# CITY OF DELRAY BEACH

### CITY COMMISSION STAFF REPORT

#### 46 Marine Way

Meeting	File No.	Application Type
August 19, 2025	2024-133	Certificate of Appropriateness, Relocations, Variances, & Waivers

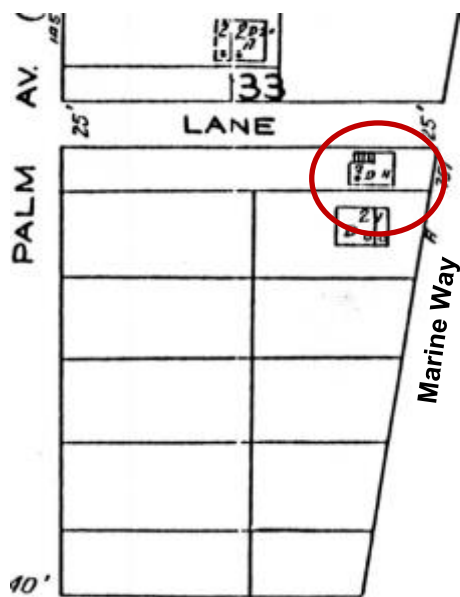
With respect to **Height**, although the proposal meets the 35 feet maximum height requirement for the zoning district, there is concern that the three-story addition is not visually compatible with the Marine Way historic streetscape. While it is anticipated that some of the third story will not be visible from the adjacent right-of-way (when viewed from the front of the property) it will be visible from the adjacent properties to the south, west, and north and from a distance further away in the historic district. Having particular impact on the adjacent historic property to the south, as the addition is proposed to be 42 feet tall measured from grade to top of roof of the third floor (the proposed 35 feet maximum overall height is measured from finished floor elevation, and such is permitted by the LDRs within FEMA flood zones). Existing historic/contributing residential structures within the Marina Historic District are one or two-stories. The proposal also does not meet the LDR requirements for Building Height Plane (BHP), with a large portion of the new addition proposed within the “no build zone” (a waiver to this standard has been requested and is analyzed further in this report).

There is concern with the proposed **Proportion of Openings (Windows and Doors)**, in that the rhythm and placement of the windows on the existing structure may no longer reflect the window pattern of the historic structure. Also, the placement of windows/doors that correlate to the use and floor levels within the building creates an array of window placements on some of the building elevations. There are concerns that the proposed window sizes could create a conflict with the transition of the original structure to the new addition, but their placement does aid in providing distinction between floors. For example, the original sliding glass doors on the rear/west side of the guest cottage are being retained at the 3<sup>rd</sup> floor level and appear out of place at that plane. The existing awning style window on the same elevation is also proposed to be retained, where it would be standard practice to replace it with a single-hung window. Consideration could be given to modifying the sliding glass door opening to accommodate a balcony or to incorporate the use of standard windows that are in line with the design of other proposed windows. All of the windows on the existing residence are to be replaced with impact resistant, clear, no low-e, non-reflective, no tint glass; with nearly all of the existing openings remaining in their original location. On the south elevation, a square window is to be replaced with a single hung window.

**Waiver Request 1:**

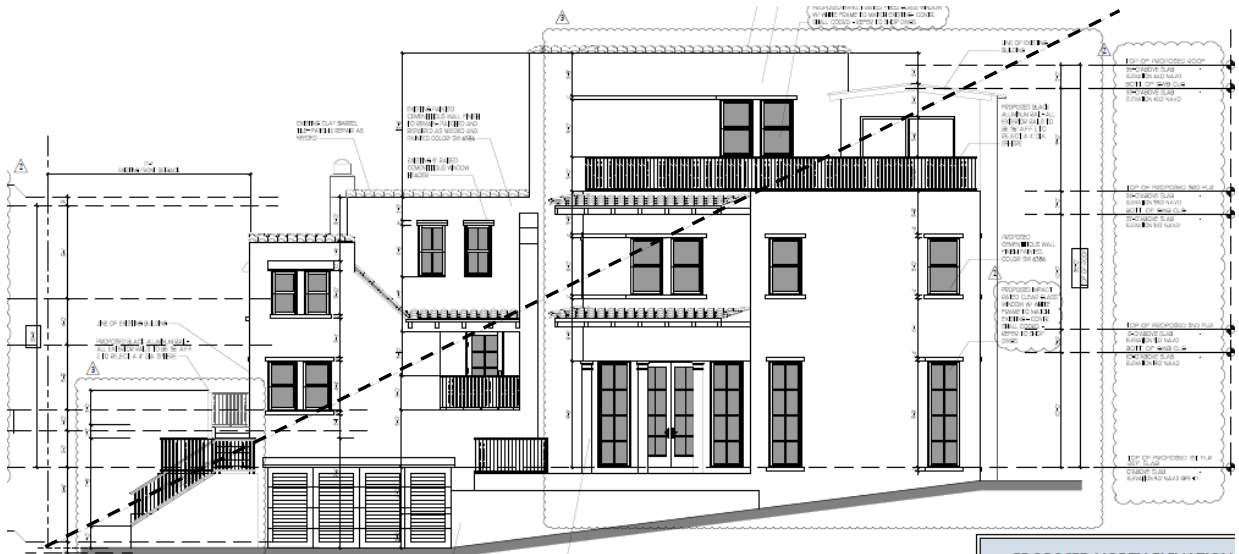
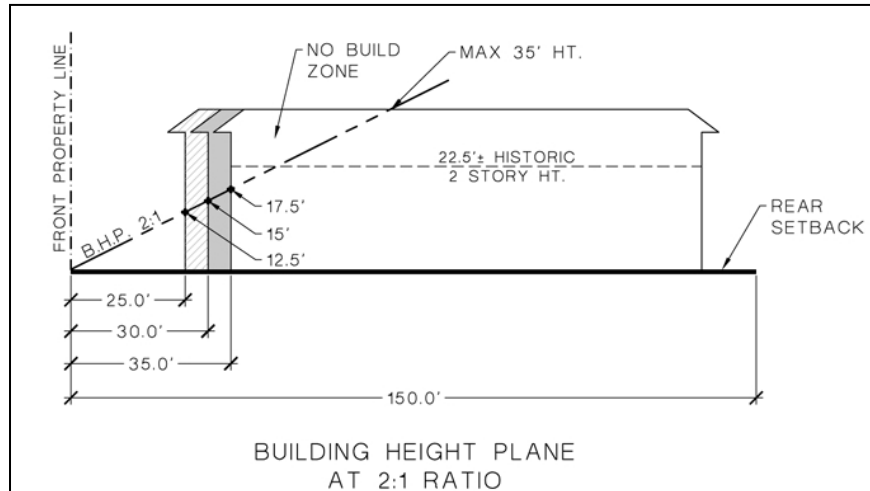
The Waiver request is to allow the addition to the front addition and existing vertically elevated structure to encroach within the required 2:1 Building Height Plane ratio.

waiver is necessary. Should the structure be elevated to a 9 feet finished floor elevation rather than a 14 feet elevation, the impact of the massing upon the area and specifically Marine Way would be reduced. Additionally, it is important to note that the entirety of the third floor of the rear addition and a small portion of the second floor of the addition also fall within the Building Height Plane (BHP) area. While some accommodation may be reasonable for raising the historic structure, extending this allowance to a three-story addition that is set back from the street should be weighed. The board will need to make a determination if the waiver adversely affects the neighboring area.

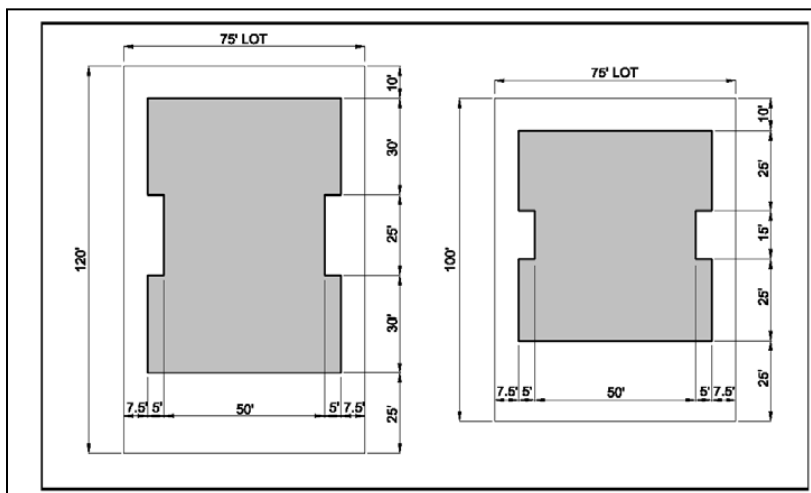
While three-story structures do exist within the historic district, they are limited to newer built structures. The subject property is smaller than the minimum requirements for a lot in the R-1-A zoning district, so minor constraints on the square footage that can be built on the property exist. However, it is noted that the proposal is for a 3,814 sq. ft. addition to the front and rear of the 1,328 sq. ft. historic structure and 296 sq. ft. pool house. The proposal will result in a building containing 5,457 sq. ft. on the 4,972 sq. ft. lot. Smaller, non-conforming lots are common within historic districts, such was the development pattern at the time of historical development. Therefore, it is possible to construct an addition that can be considered more secondary and subordinate to the main structure. The board will need to determine if the waiver results in a special privilege and if the same waiver would be granted under similar circumstances on other property. It is noted that there are two other COA's in process for the two properties immediately to the south of the subject site.
